Project Name Berth 2 Fender Refurbishment

Project No. 11089 Task No. 01 Addendum No. 1

Alabama State Port Authority Pre-Bid Meeting Minutes

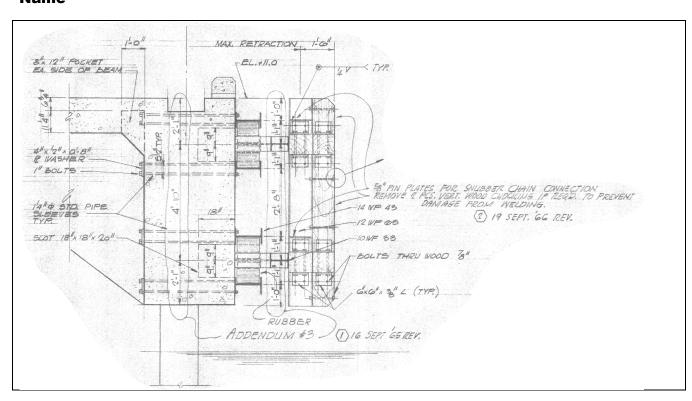
Question 7: Will drilling and epoxying new bolts to the existing concrete face be permissible to attach the one new adapter plate? If so, please specify a depth of embedment and epoxy for these six bolts.

Answer: See attached showing, showing through bolts and sleeves. The intention is to replace these bolts as shown on the drawing.
